CITY OF ST. AUGUSTINE CORRIDOR REVIEW COMMITTEE

A G E N D A

5. (a) HP2024-0032 Nine Oaks Development, Inc. - Applicant
Broudy Bros., Ltd. - Owner
212 W. King Street

GATEWAY PARKING GARAGE & RETAIL/ OFFICE BUILDING
WEST KING STREET
ST. AUGUSTINE , FLORIDA

A0.50

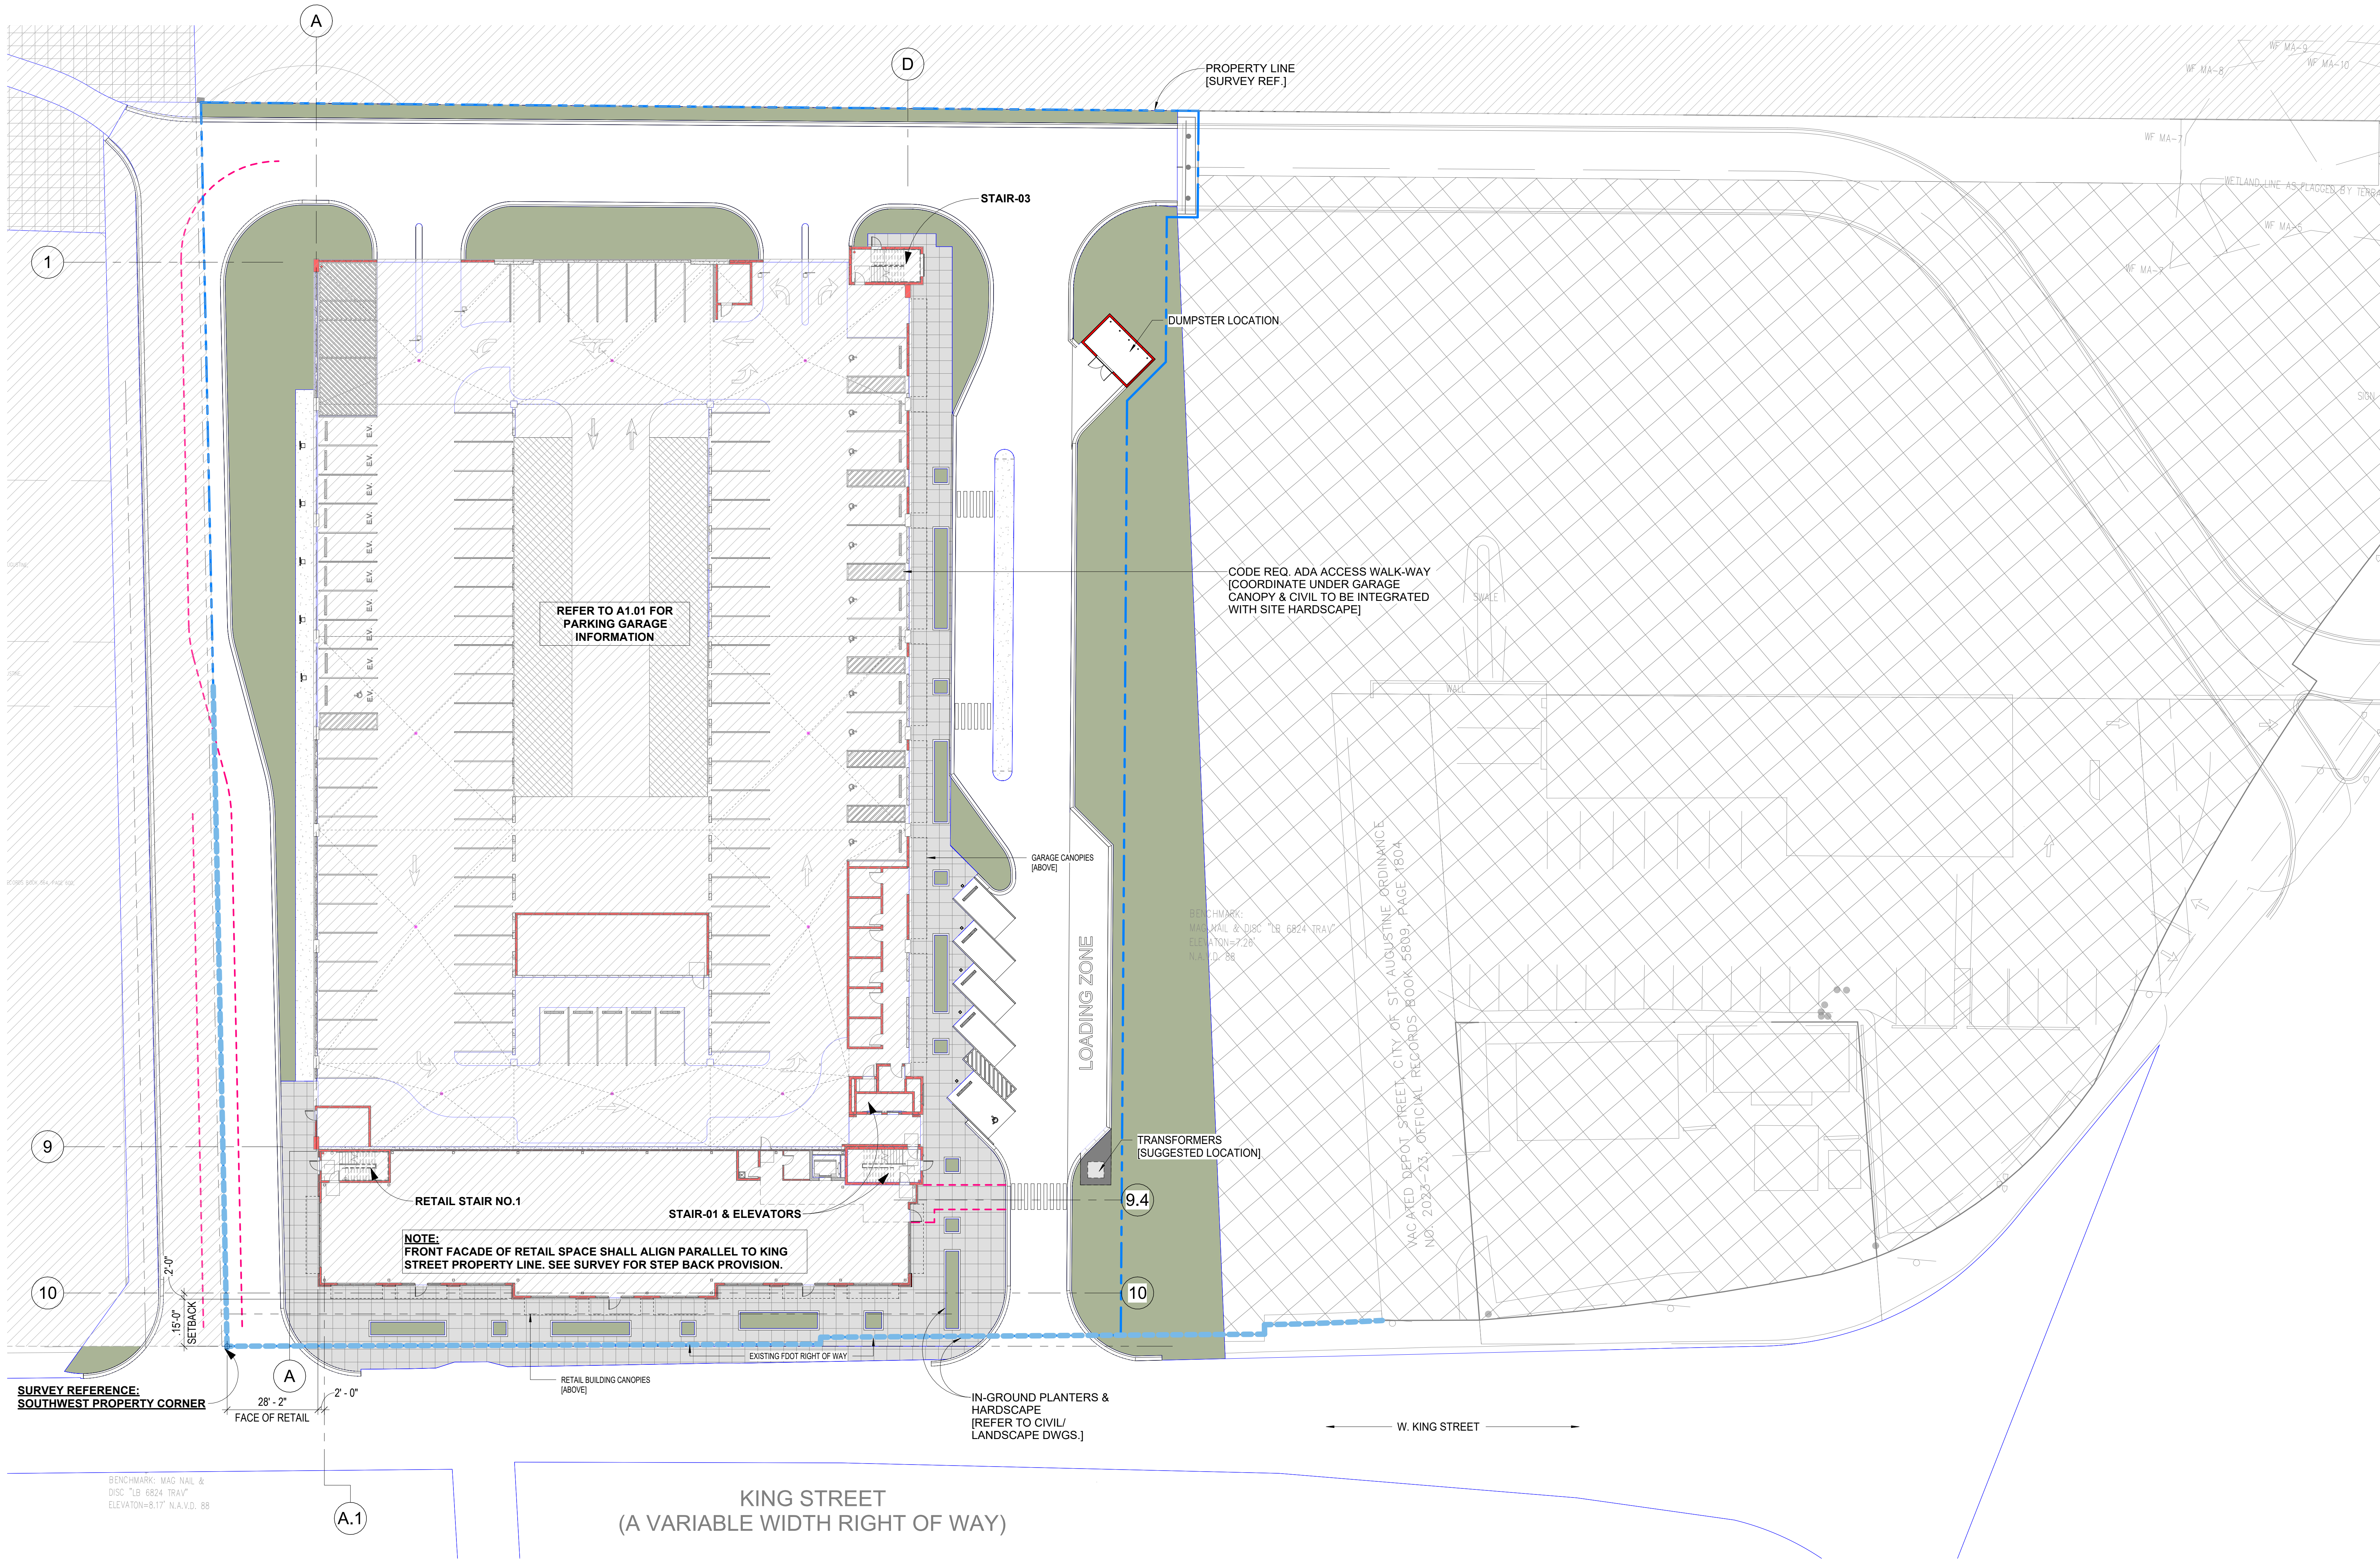
- b. Proposed awnings should be clearly indicated on the site plan with setback measurements to ensure they do not encroach over the right-of-way. **Response: Awnings are indicated on the revised Architectural Site Plan – Sheet A0.50. Awnings do not encroach over the FDOT right-of-way.**

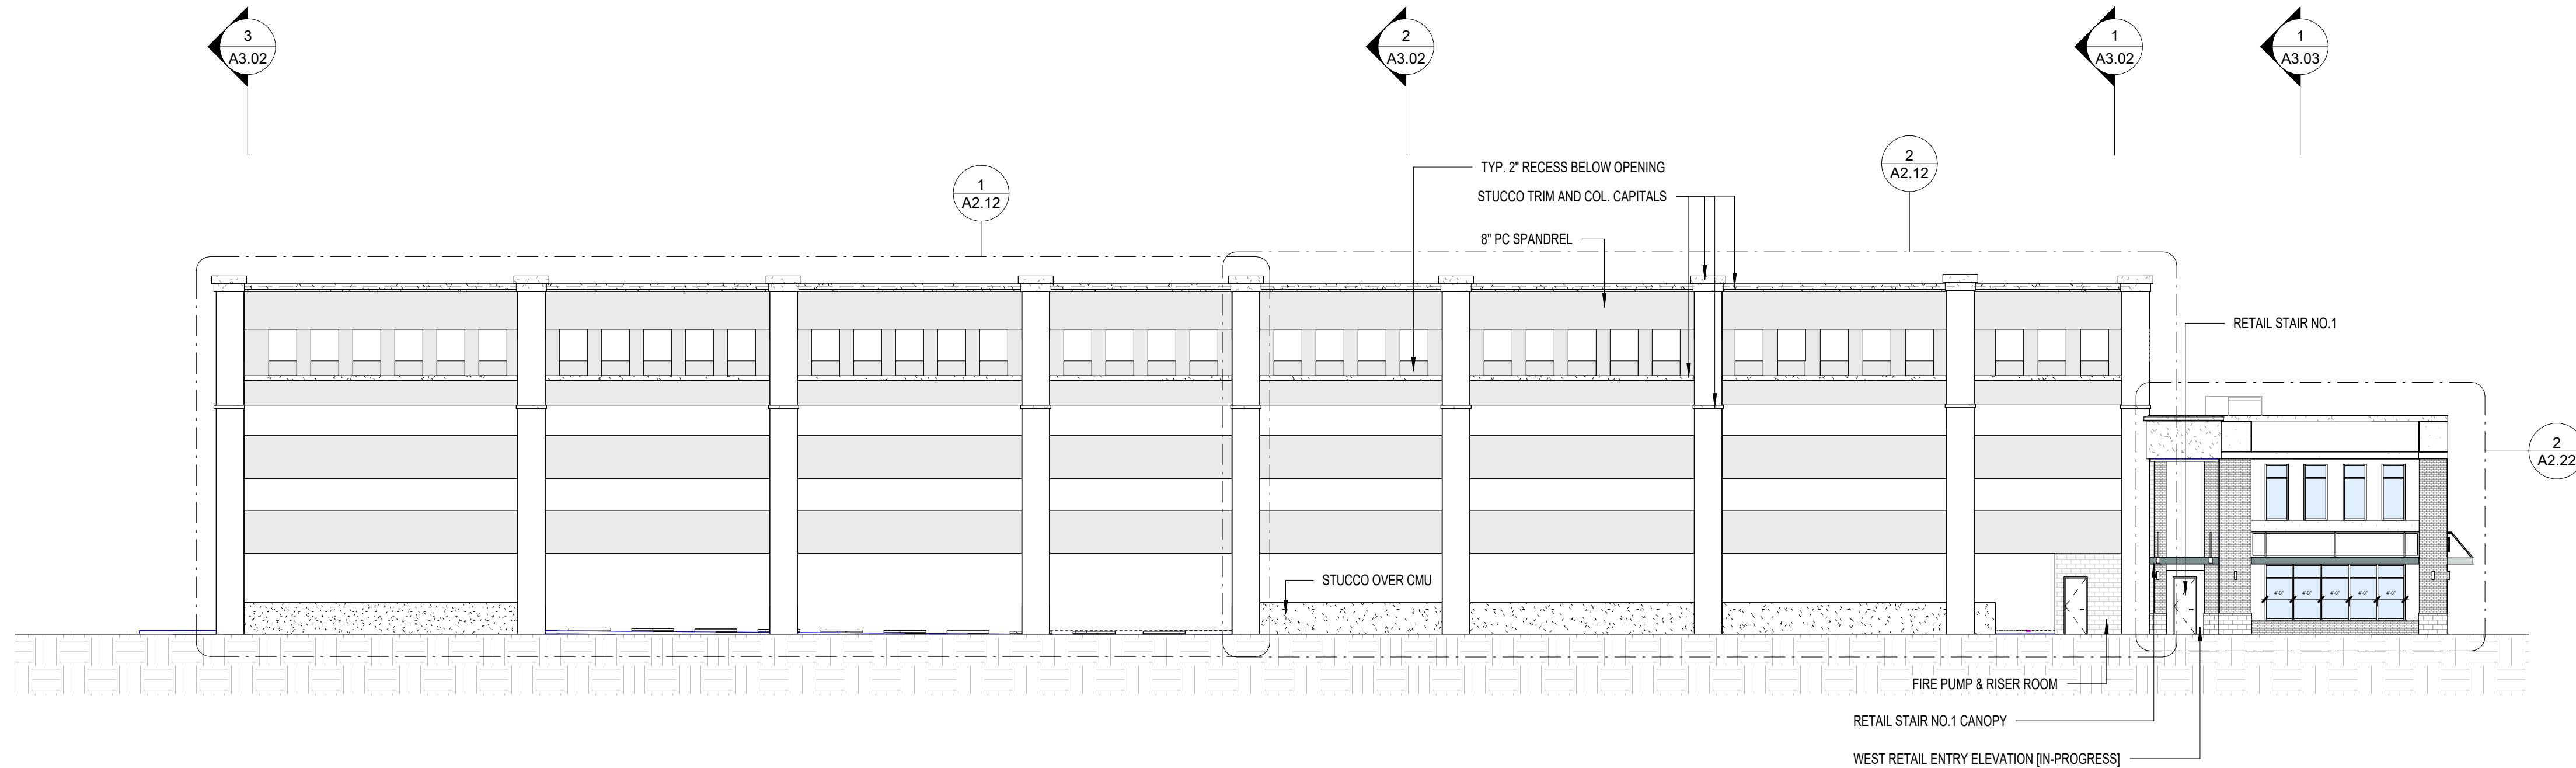
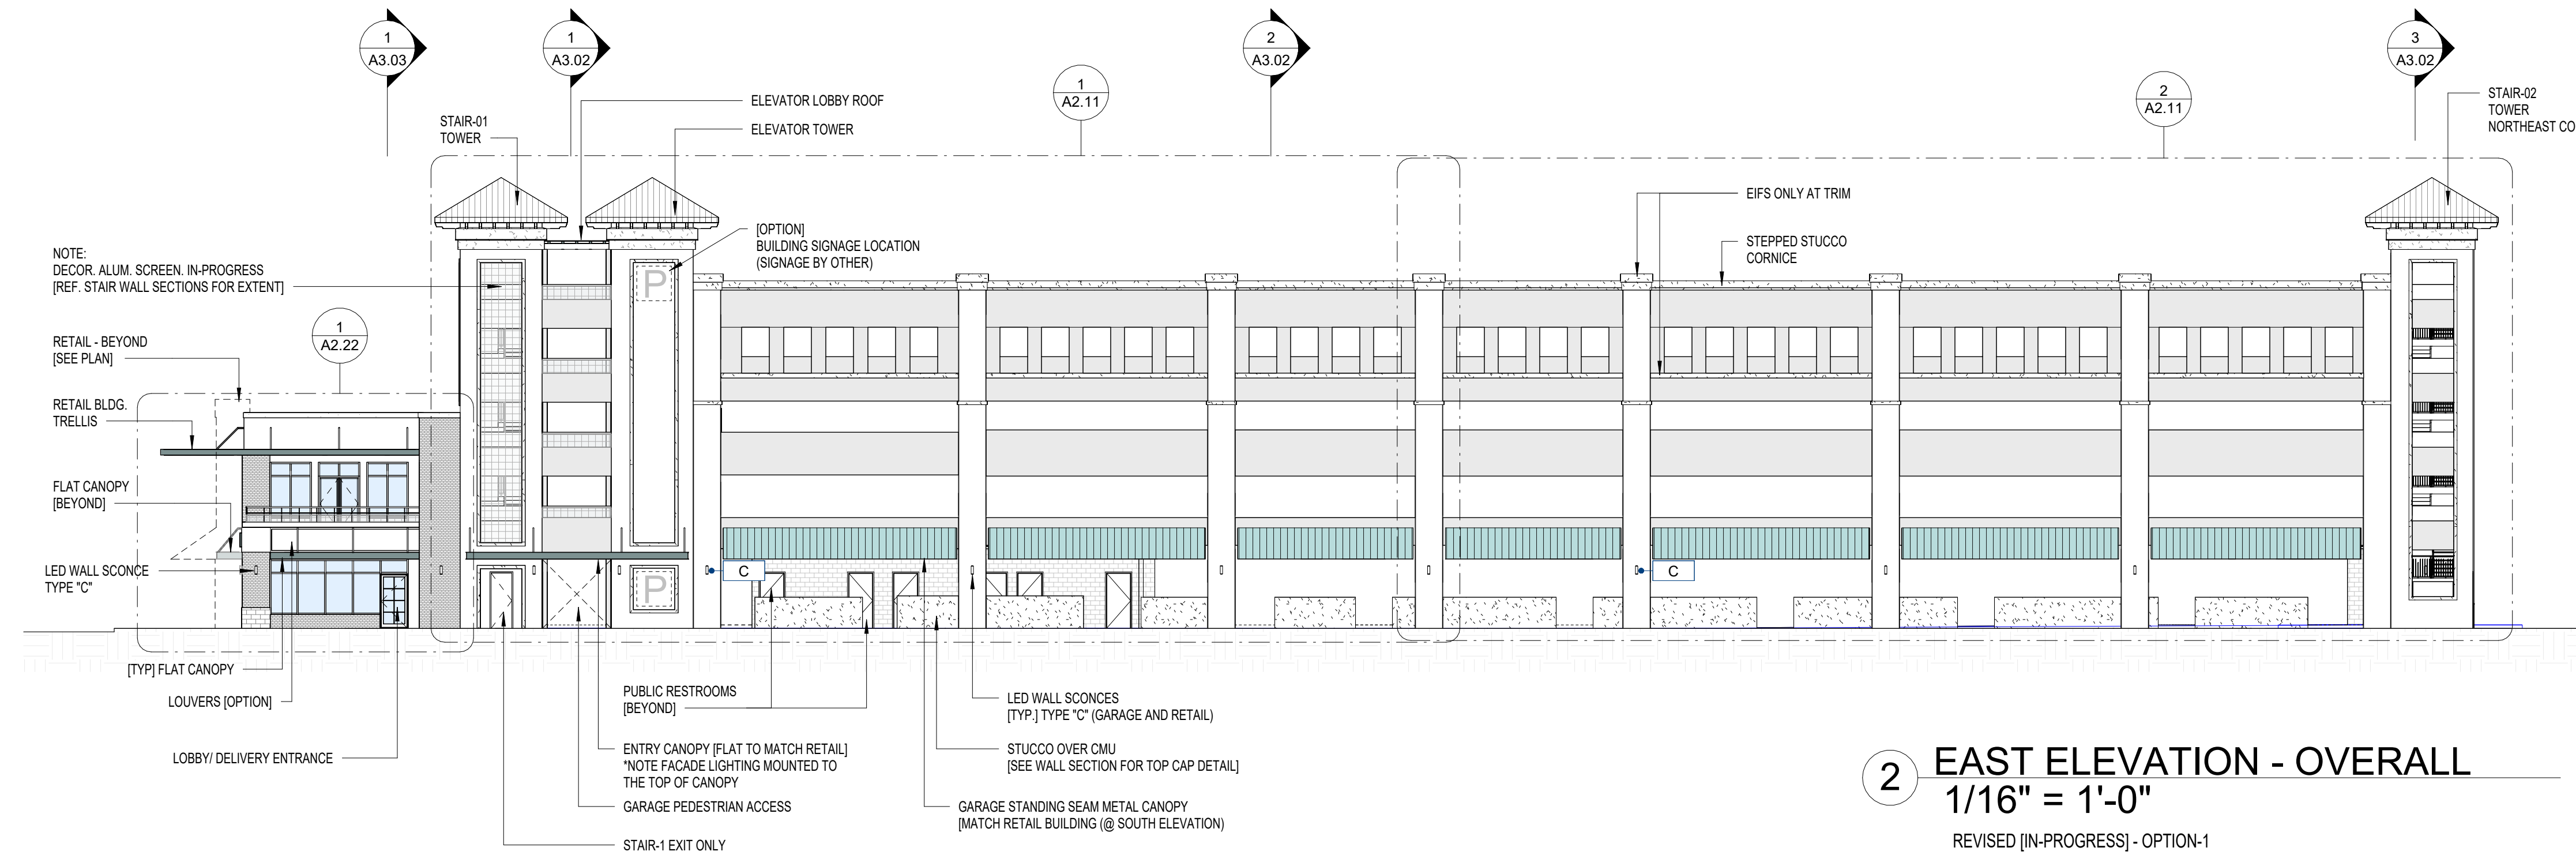
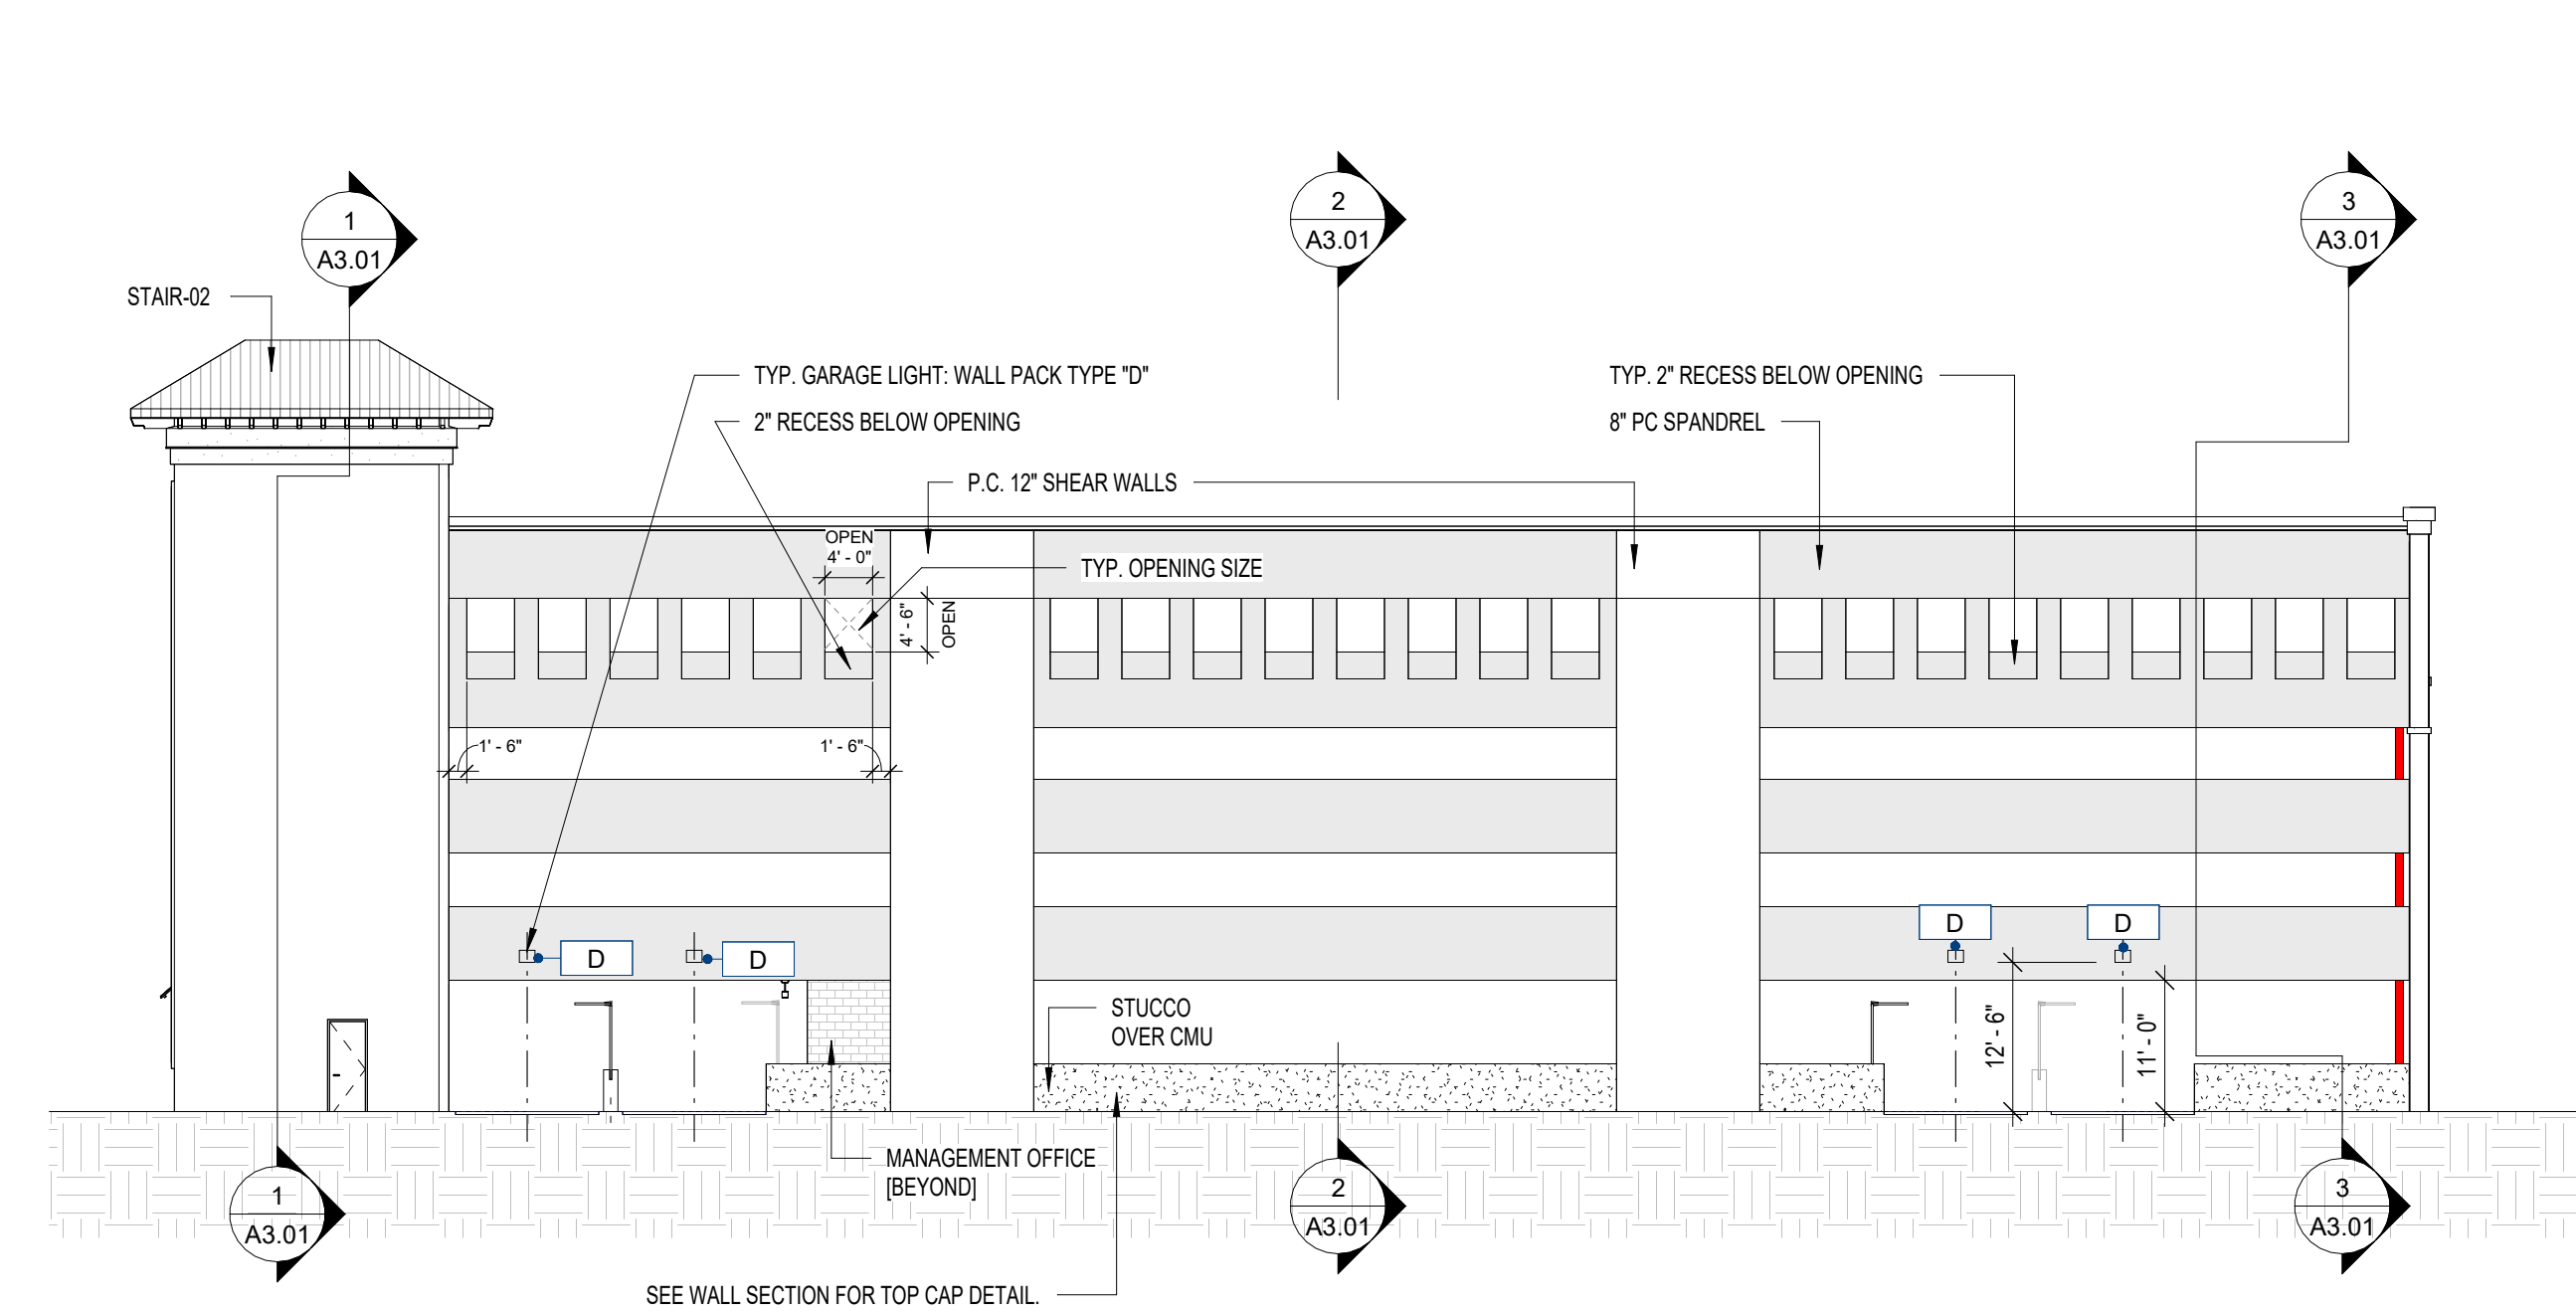
- j. Bulkheads between 12 and 30 inches above the finished floor are required per the DSEC. The proposed storefront systems and proposed elevation drawings do not feature bulkheads. **Response: The design has been revised to include 24-inch-high bulkheads. See Sheets A0.14, A2.01 and A2.21.**
